CONCEPT PLAN III
STREET BAPTIST
ALEXANDRIA, VIRGINIA

Mr. Michael Swidrak, AICP
Urban Planner
City of Alexandria
Development Division
301 King Street
Room 2100
Alexandria, VA 22314

We are in receipt of your comments dated June 21, 2016. Many changes have been incorporated into this submission based on City Staff as well as Community input, including adding a third level of underground parking on site. As a result, the Applicant is submitting this Concept III submission so Staff has the most current plans being proposed. The following are our responses to your comments:

FAR DEDUCTIONS

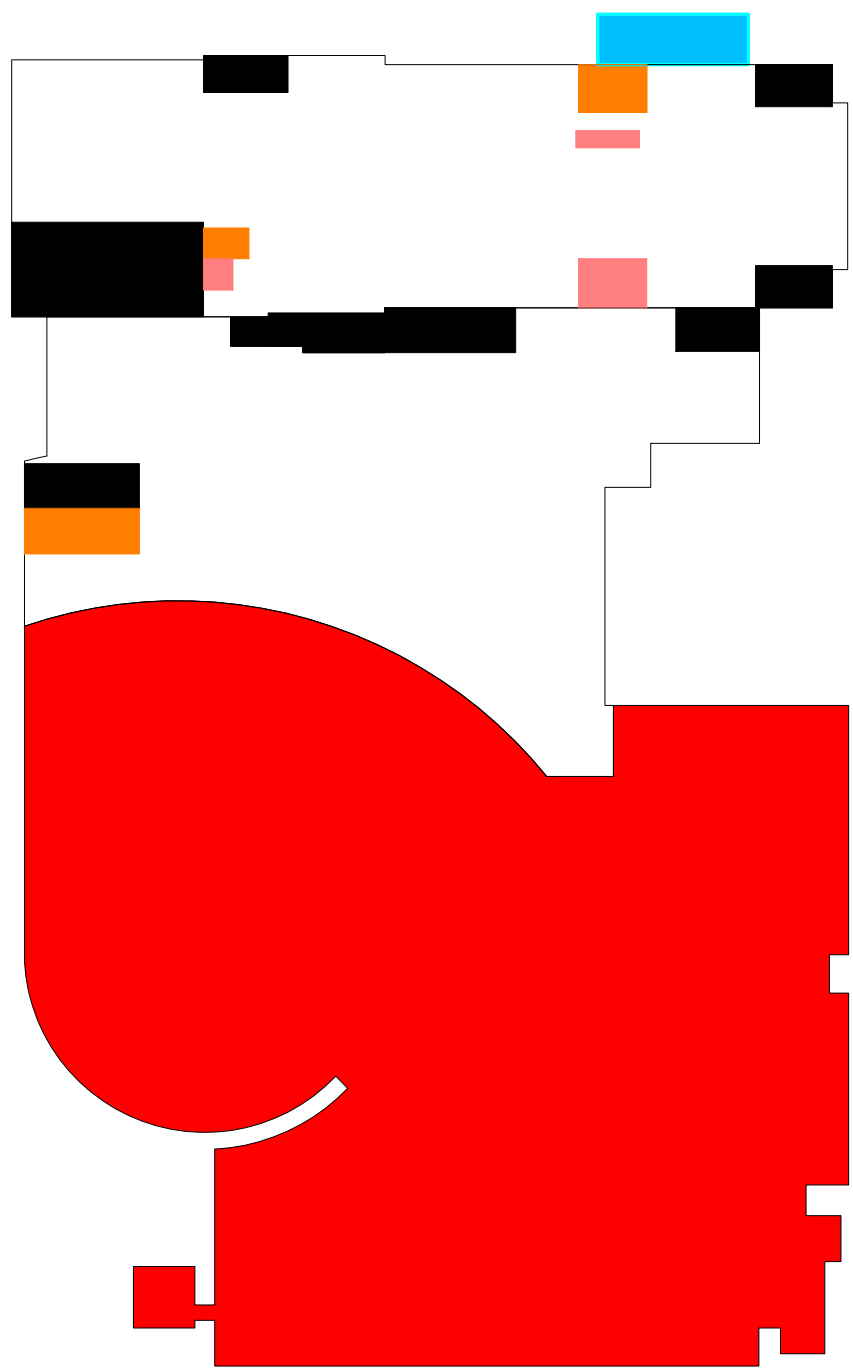
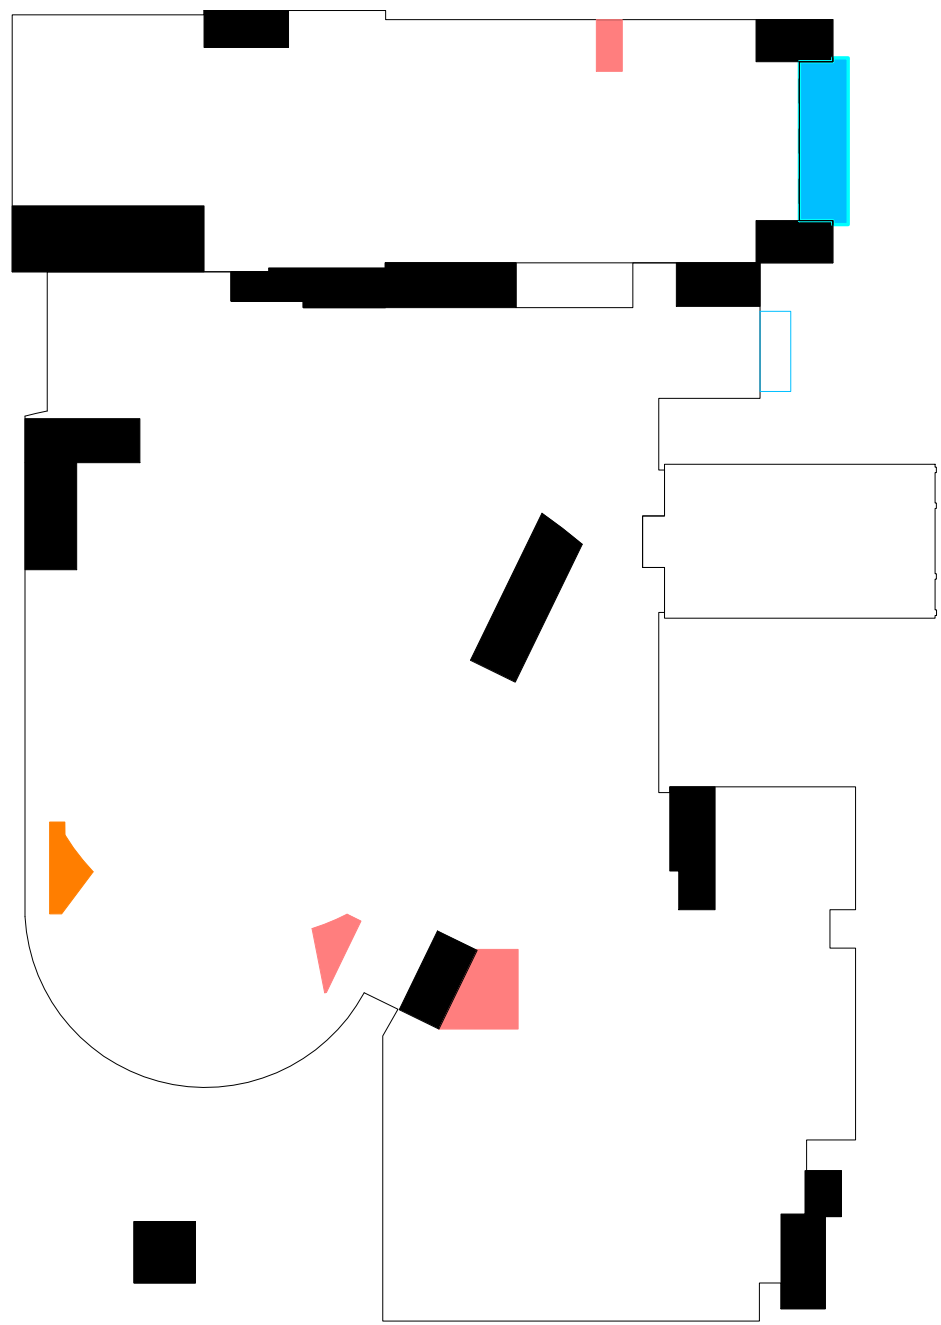
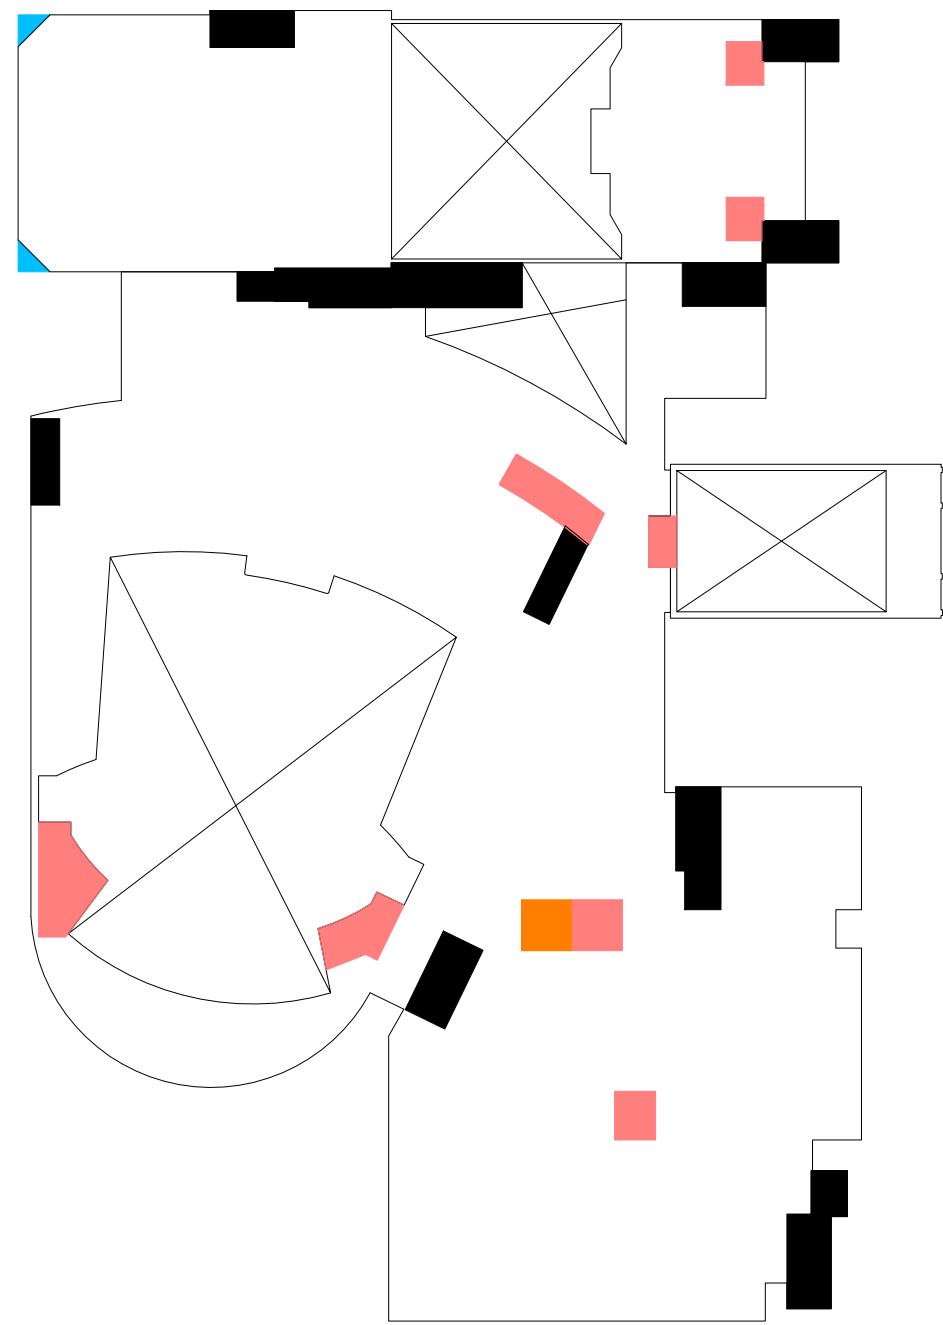
9. Applicant must provide FAR deduction diagrams on plan sheets with next submission.

Response: FAR deduction diagrams are included with this submission.

① WOLFE STREET
1" = 20'-0"

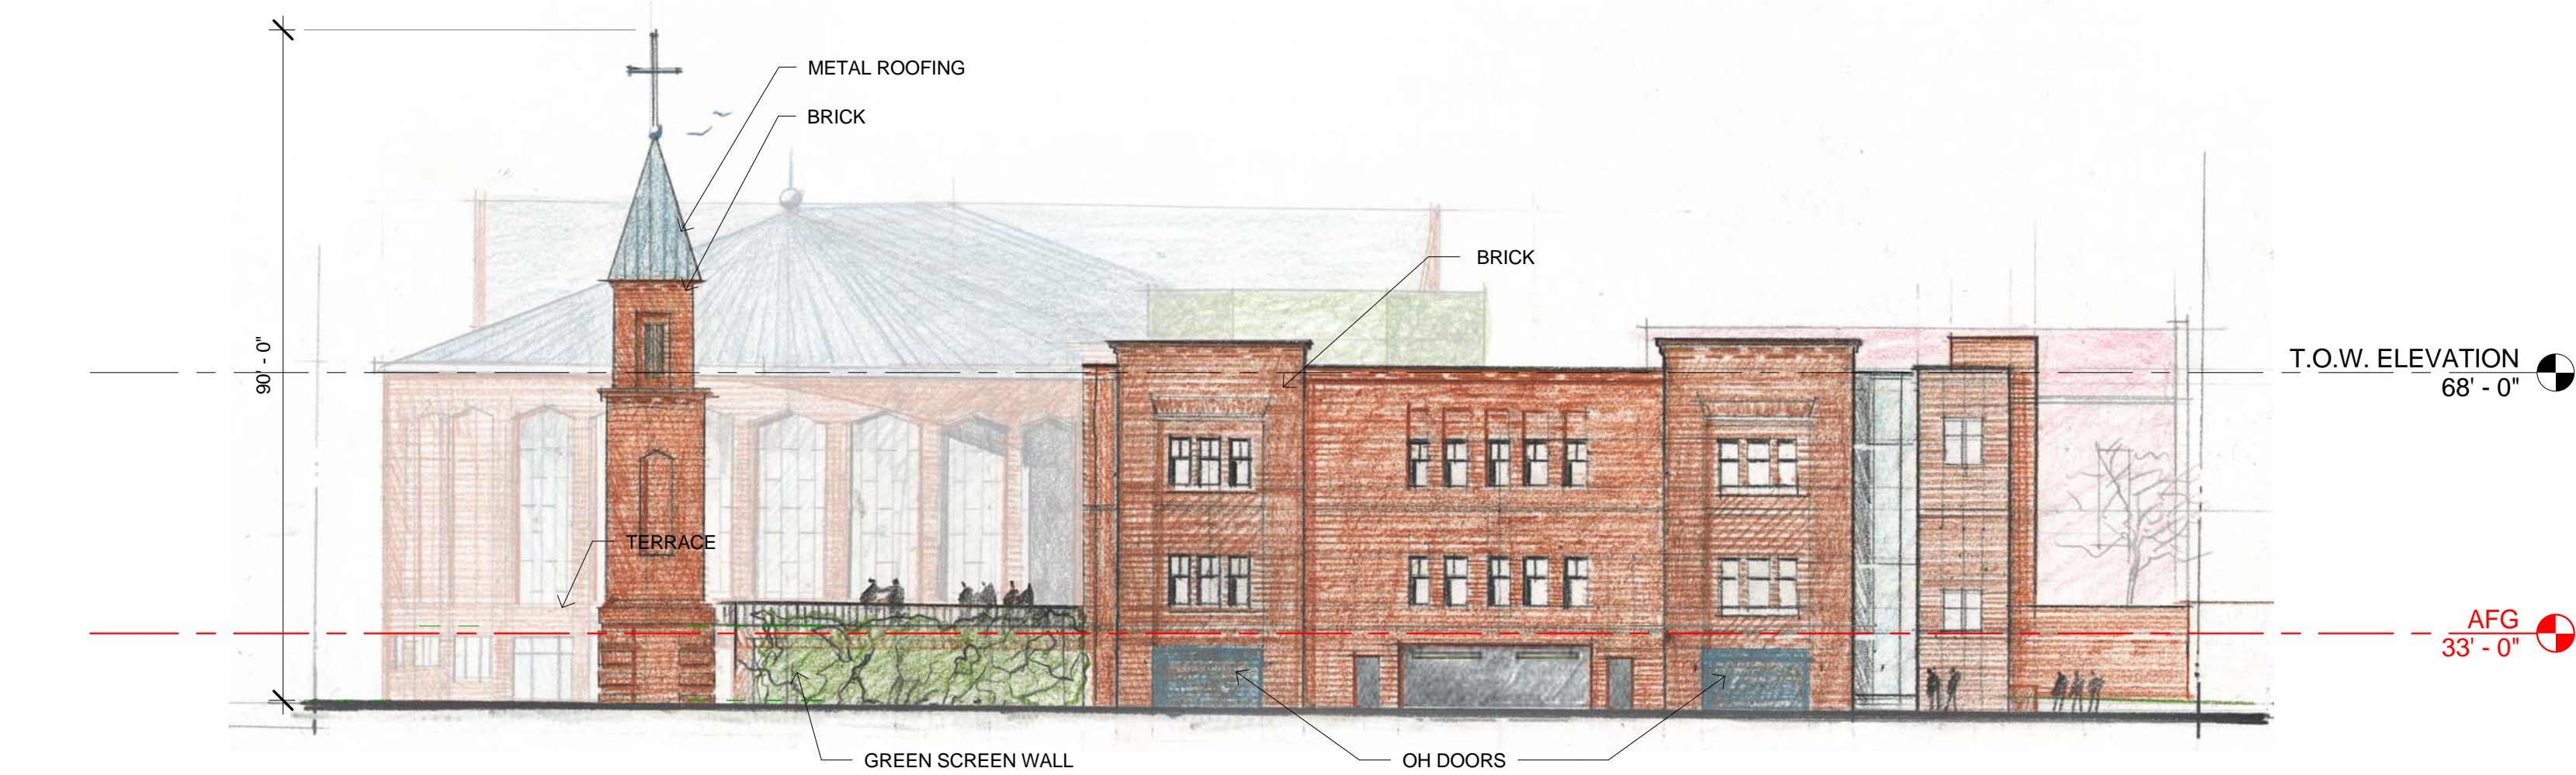
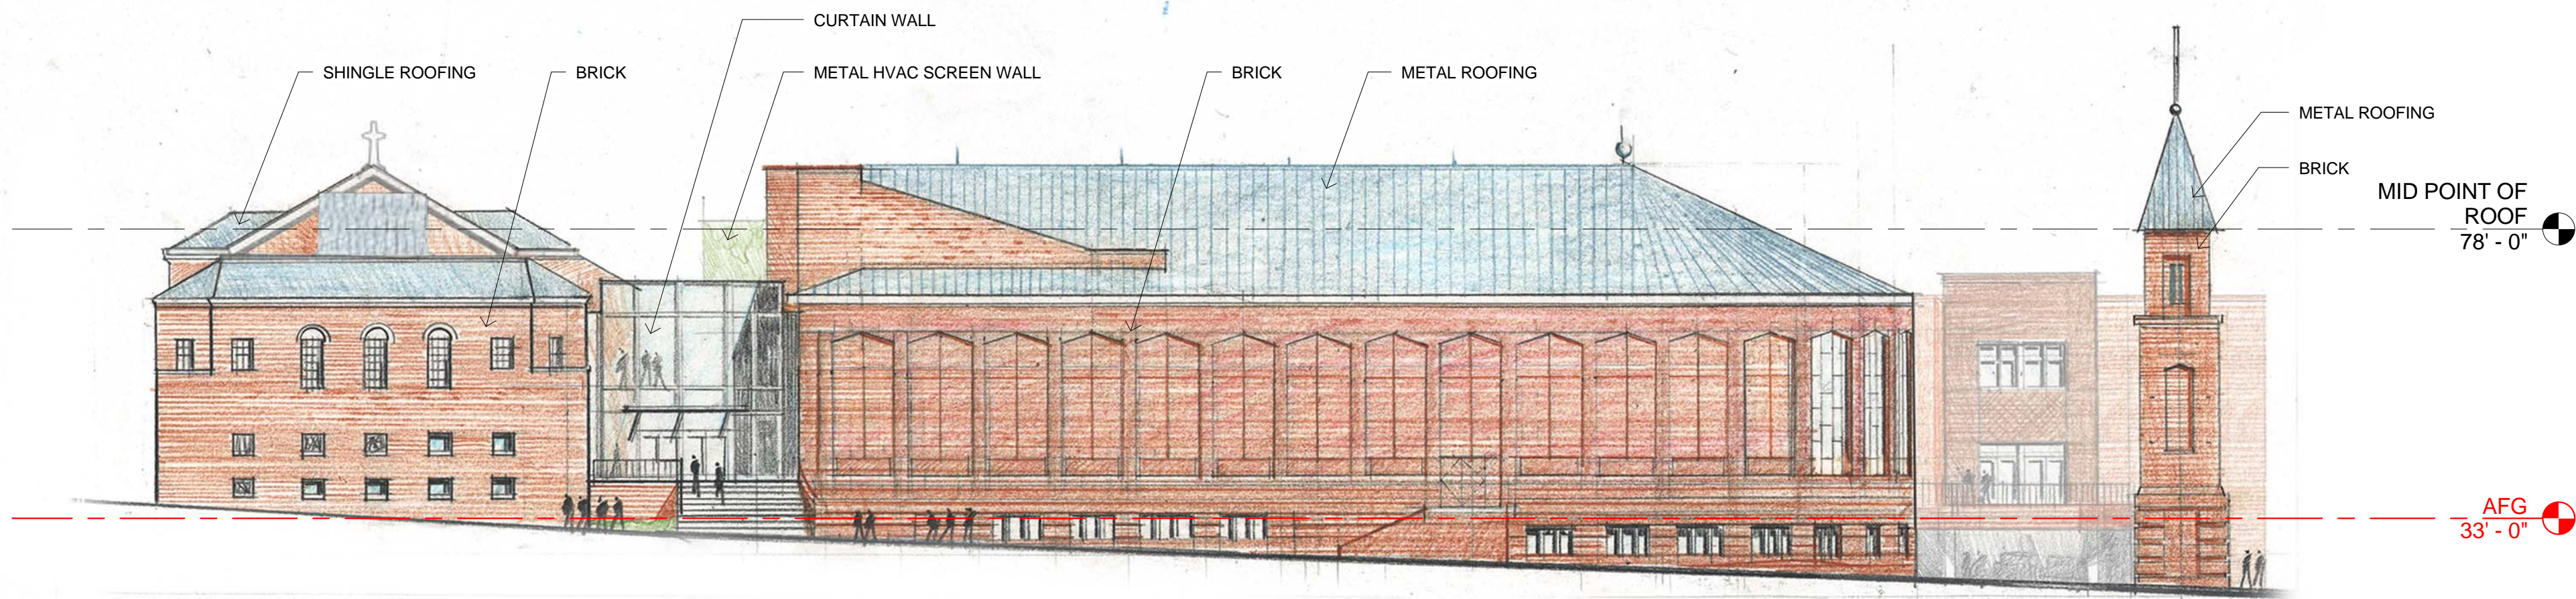
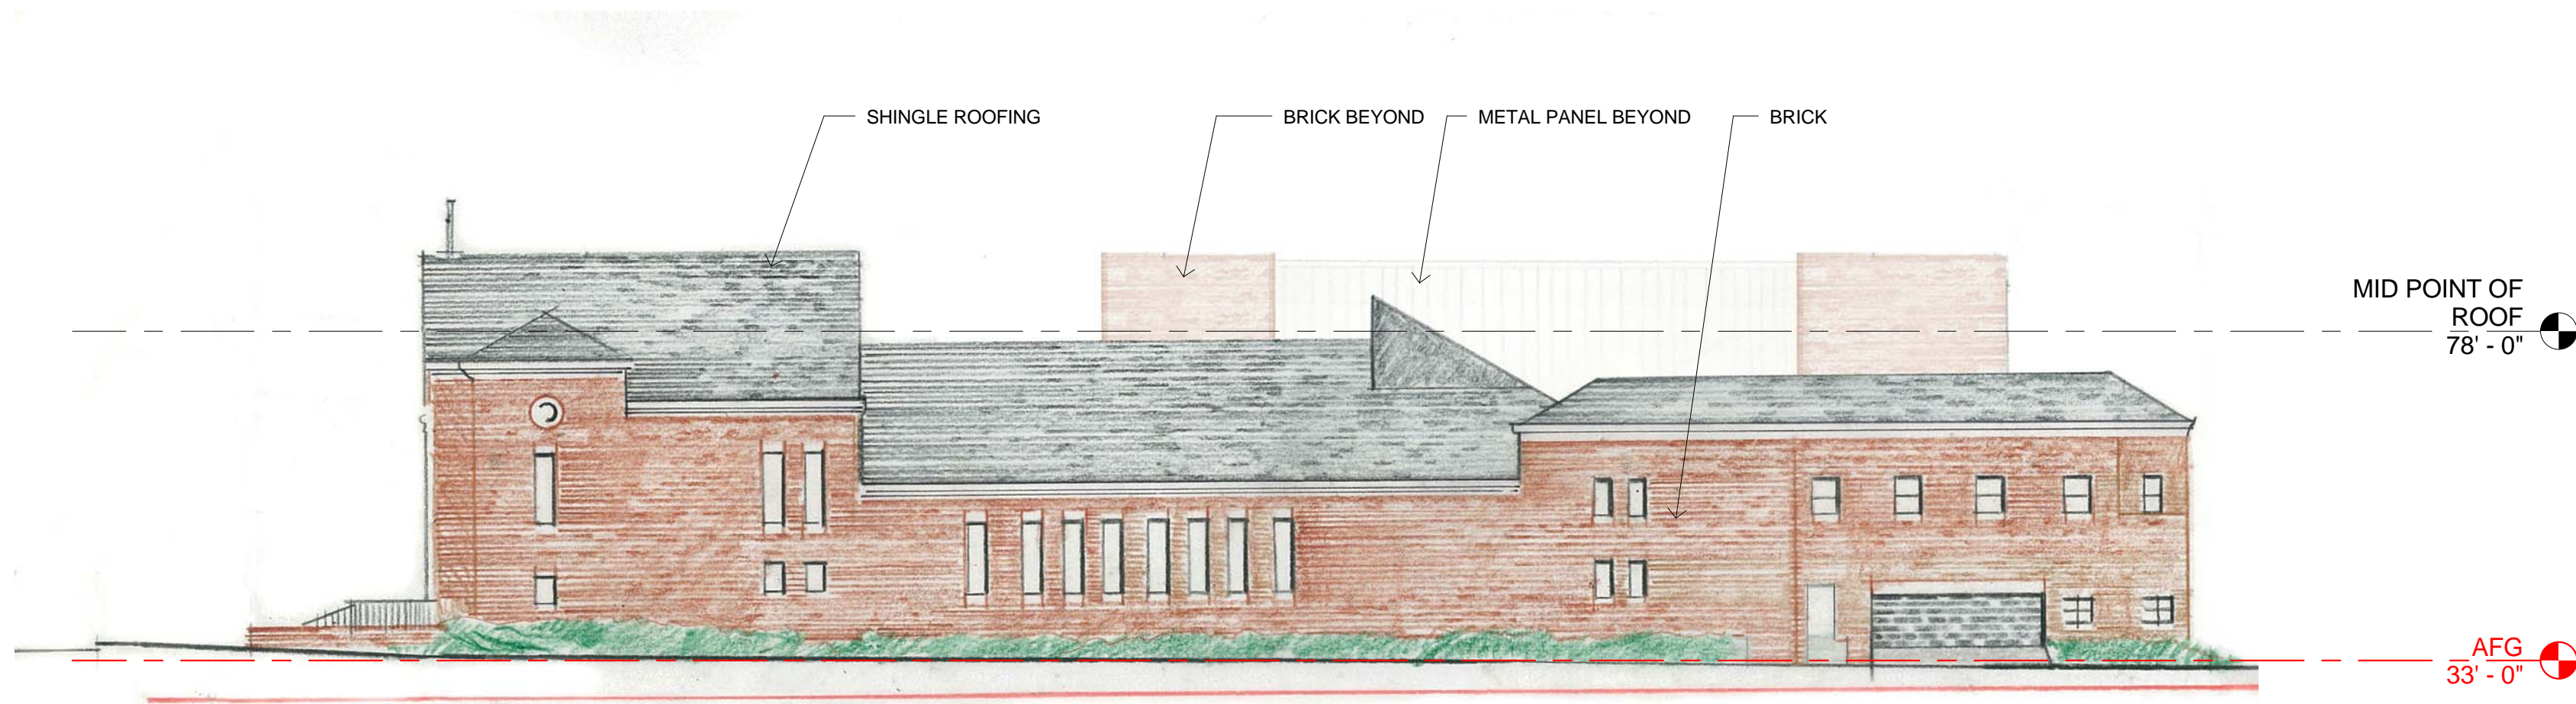
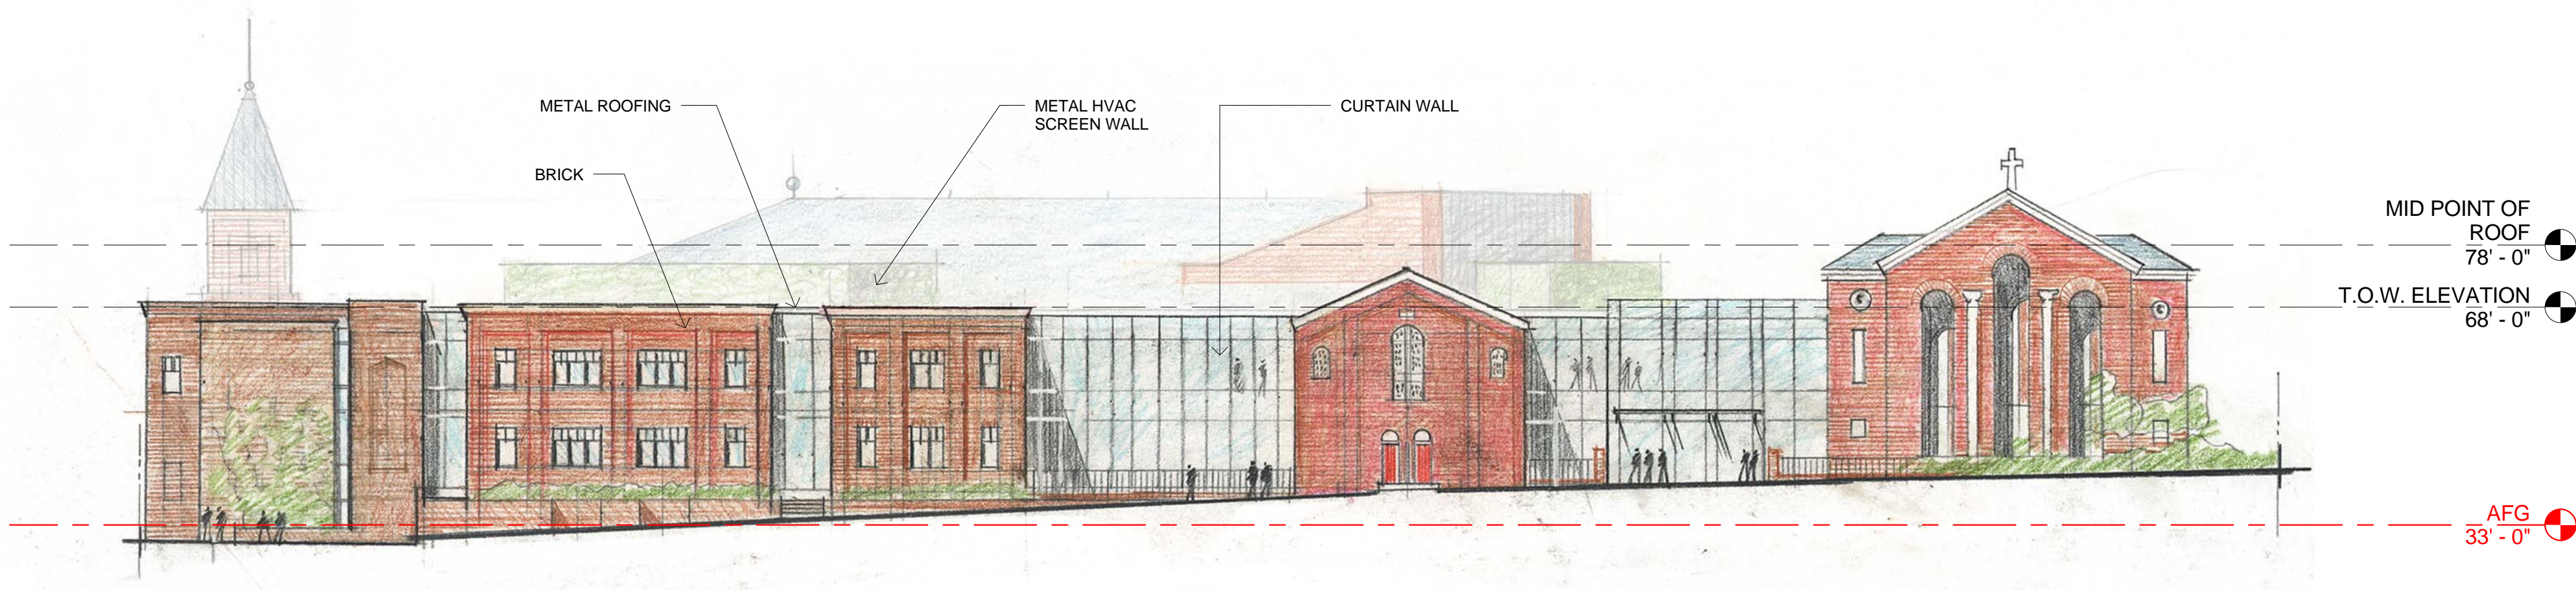
6. Applicant must call out height from AFG on all elevations sheets to show compliance with the 45 foot height maximum. Please clarify if the average finished grade is 33.0 feet or 32.8 feet on Sheet C200.

8. The height of the entire steeple must be included on the architecture elevations to show compliance with the 90 feet maximum per Section 6-403(C) of the Zoning Ordinance. This includes the height to the top of the cross above the spire.

Response: AFG is 33.0

Response: The height of the steeple including the cross will not exceed 90 feet.
